SUBJECT: Forwards addl info re review completion of NUREG-0737, Item II.B.1, concerning RCS high point vent sys.

DUKE POWER COMPANY
OCONEE NUCLEAR STATION

Response to NRC Request for Information
RCS High Point Vent System

OCONEE UNIT 1 - SYSTEM BLOCK DIAG. REACTOR COOLANT SYSTEM HIGH POINT VENT VALVES

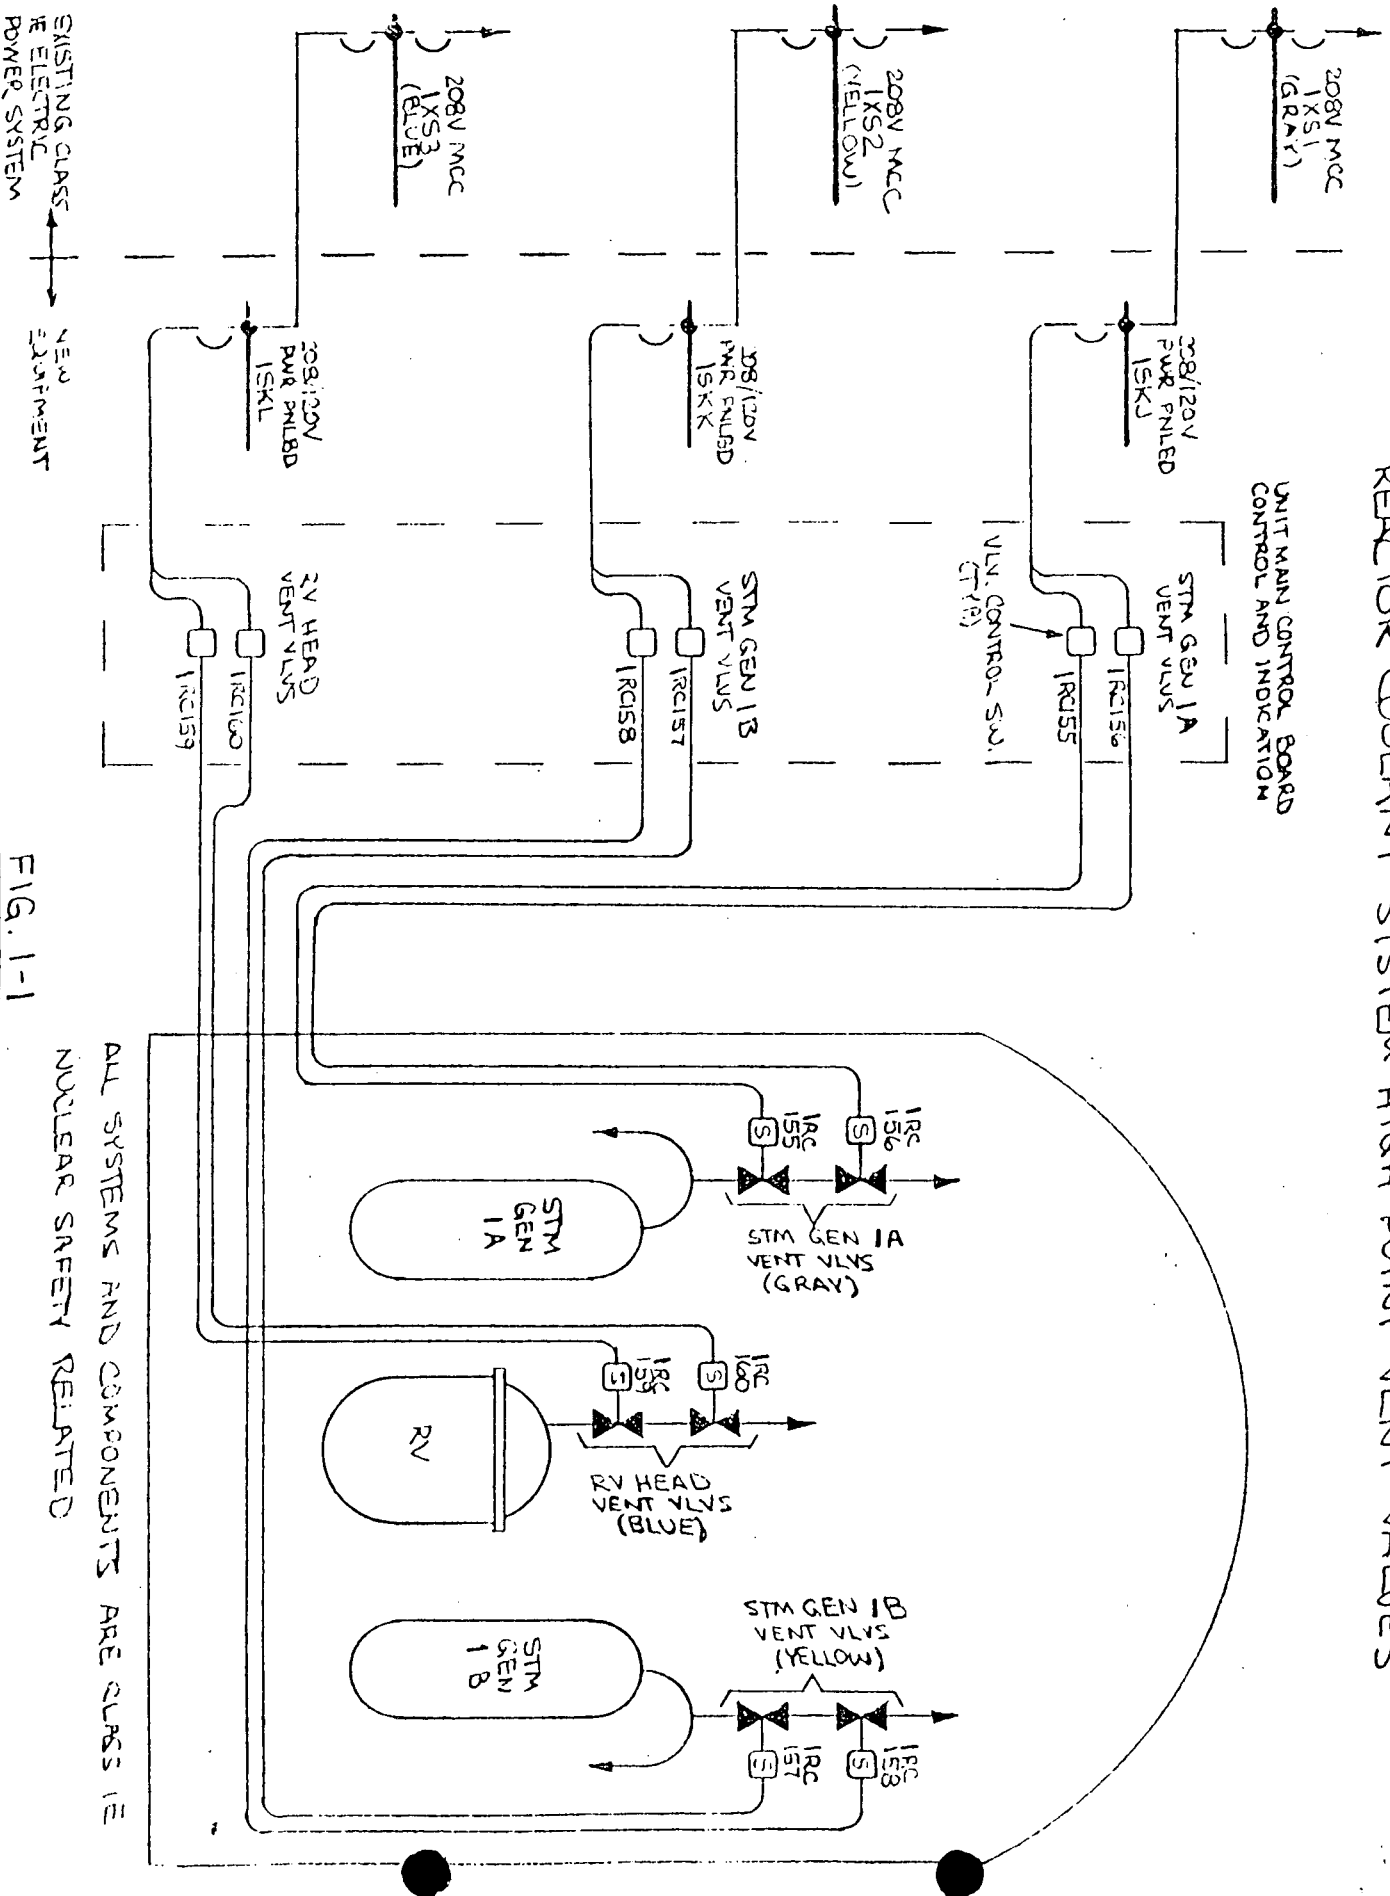
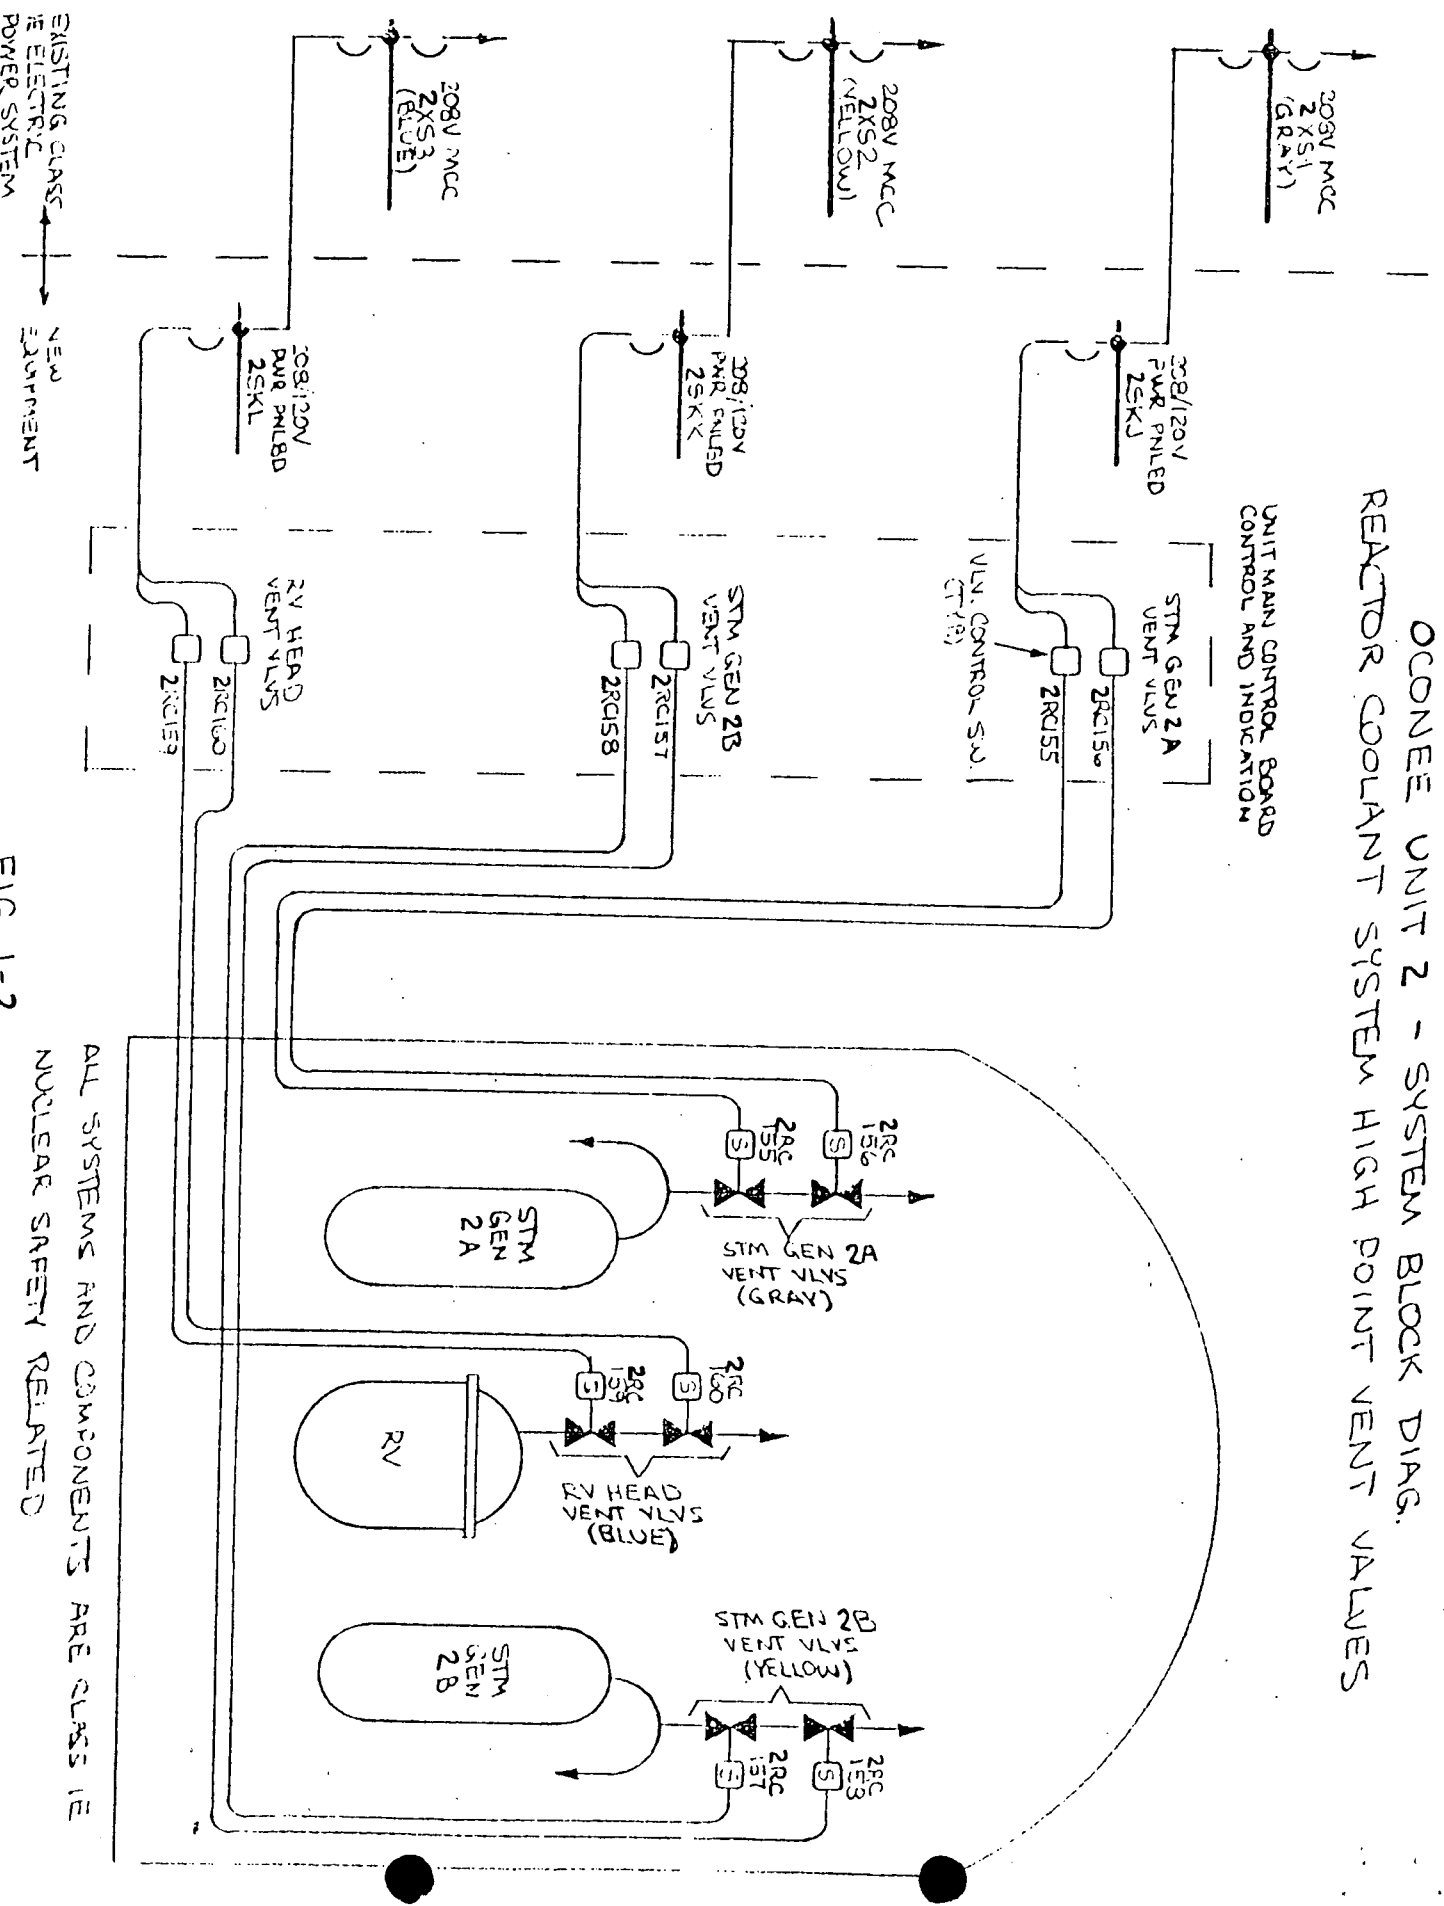
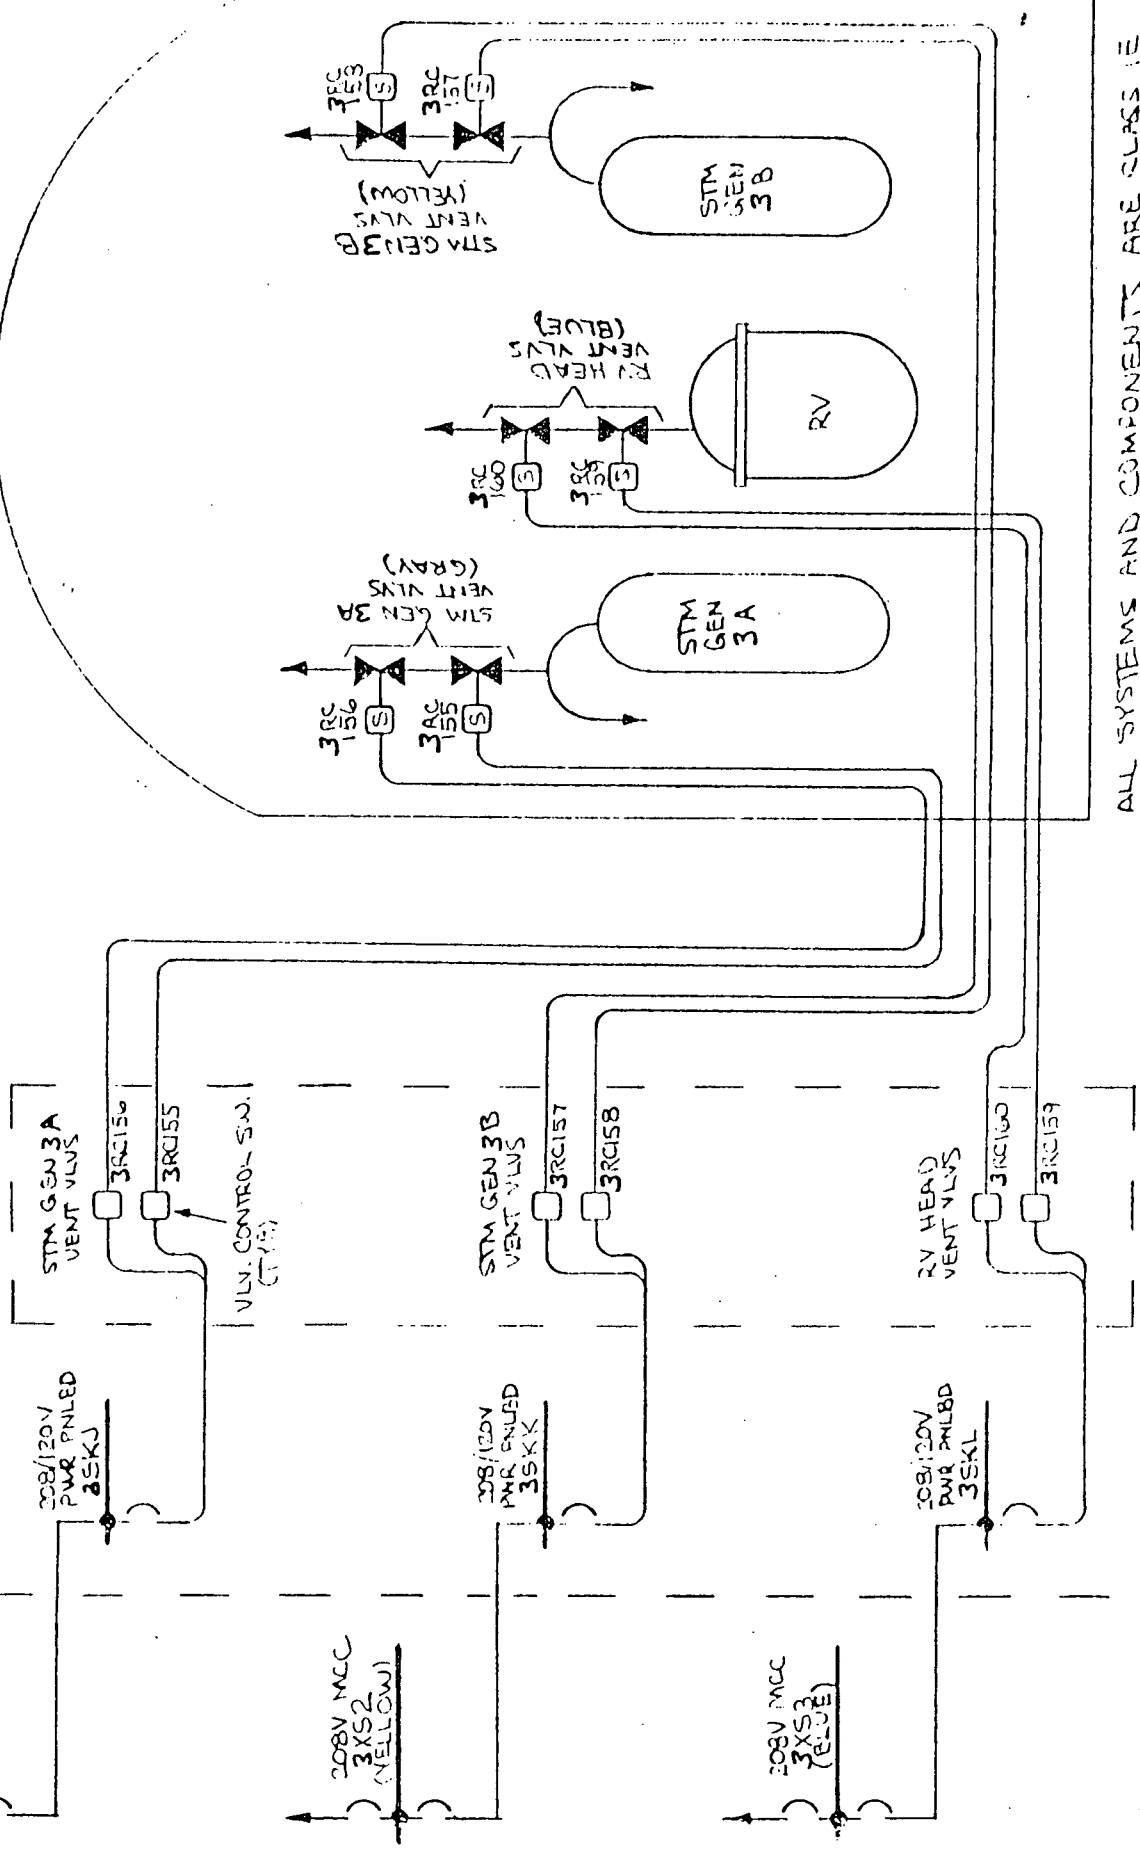
9. Describe the design features or administrative procedures, such as key locked closed valves, alarms, or removal of power during operation, that will be employed to prevent inadvertent actuation of an RCS high point vent path (reference NUREG-0737 Item II.B.1 Clarification A.(7)).

Administrative procedures employed to prevent inadvertent actuation of an RCS high point vent path are described below. Since the design of all three Oconee units is identical, descriptions are written without unit designations and apply equally to all three units. The accompanying diagrams are unitized to clearly show the appropriate unit designations.

Hot Leg Loop "A" Vent Valves RC155 & RC156, Hot Leg Loop "B" Vent Valves RC157 & RC158, Reactor Vessel Head Vent Valves RC159 & RC160

The electrical control circuits for these valves are designed such that control power is normally removed from the circuit. Two separate operator actions are required to apply control power to the circuit and to energize the valve solenoid in order to open any single valve. Each RCS high point vent flow path consists of two valves in series so that four separate operator actions are required to open any one flow path.

A separate, dual function control switch (device "CS") is provided for each valve. This switch contains a maintained contact "ON-OFF" function and a momentary contact "OPEN" function. Although both functions are contained on a single switch operator housing, they are mechanically and electrically separate and independent so that, in effect, they provide redundant control capabilities.

The maintained contact "ON-OFF" function is normally set to the "OFF" position. In this position, electrical power is removed from the valve control circuit so that the solenoid coil cannot be energized to open the valve. The momentary contact "OPEN" function is normally held in the unactuated state by the spring return feature of the pushbutton operator. In this position, the control circuit is open so that the solenoid coil is not energized and the valve is closed. Thus, electrical power to the solenoid valve coil is interrupted at two points, and separate operator

To open a valve, the operator places the respective maintained contact switch in the "ON" position and depresses the associated momentary contact "OPEN" pushbutton, completing the electrical control circuit to the solenoid coil energizing the solenoid valve.

Each valve control switch contains safety-grade valve position indicating lights in addition to the dual control functions previously described. Thus, the operator has at all times immediate verification of vent valve position which is intimately and conclusively associated with the valve control function. The indicating lights are directly operated by limit switches which sense the position of the valve stem in the solenoid valve actuator.

All portions of the control and indication circuits are designated and qualified as Class 1E Nuclear Safety Related and meet all seismic qualifications. All control and indication functions are located remotely on the unit main control boards in the respective unit control rooms. The control switches for the two series valves in each vent flow path are located immediately adjacent to each other so that an operator can quickly set up and operate any vent path and verify valve operation from a single operating position, yet the system remains resistant to inadvertent actuation.
